Access Compliance Report

Public Rights-of-Way

(Curb Ramps)

Intersection ID: 44001	Main Street: ELROSE_PL	Cross Street: N/A	Location: SW
ADA ID: 8280F80F12B9	Ramp Type: Perp	Initial Pass/Fail: Fail	Overall Compliance: No
Severity Score: 30			
Codes/Mitigation Info/Possible Solution		Field Measurements/Component Compliance

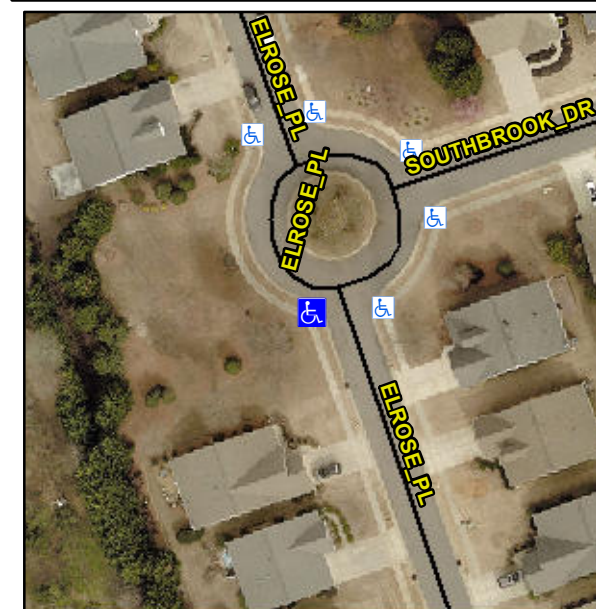
Not Found, R304.5.1, R304.5.3

Compliance	Description	Data	Compliance	Description	Data
N/A	Ramp Length (in)	100.0	Yes	Ramp Slope (%)	7.2
No	Ramp Width (in)	33.0	No	Ramp XSlope (%)	5.5
N/A	Flare Type LT	N/A	N/A	Flare Type RT	N/A
N/A	Flare Slope LT (%)	N/A	N/A	Flare Slope RT (%)	N/A
N/A	Flare Traversable LT?	N/A	N/A	Flare Traversable RT?	N/A
N/A	Landing Length (in)	N/A	N/A	DWS Provided?	N/A
N/A	Landing Width (in)	N/A	N/A	DWS Contrast?	N/A
N/A	Landing Slope (%)	N/A	N/A	DWS Length (in)	N/A
N/A	Landing X Slope (%)	N/A	N/A	DWS Full Width?	N/A
N/A	Landing Curb? (Y/N)	N/A	N/A	DWS Offset (in)	N/A
N/A	Shared Landing?	N/A			
N/A	Gutter Ponding?	N/A	N/A	Gutter Slope (%)	N/A
N/A	Gutter Lip Ht (in)	N/A	N/A	Gutter X Slope (%)	N/A
N/A	Painted X Walk1?	No	N/A	Painted X Walk2?	N/A
	X Walk 1 Direction	To E		X Walk 2 Direction	N/A
N/A	X Walk 1 Width (in)	N/A	N/A	X Walk 2 Width (in)	N/A
	X Walk 1 Slope (%)	0.3		X Walk 2 Slope (%)	N/A
	X Walk 1 X Slope (%)	5.5		X Walk 2 X Slope (%)	N/A

Remove & Replace Entire Ramp.
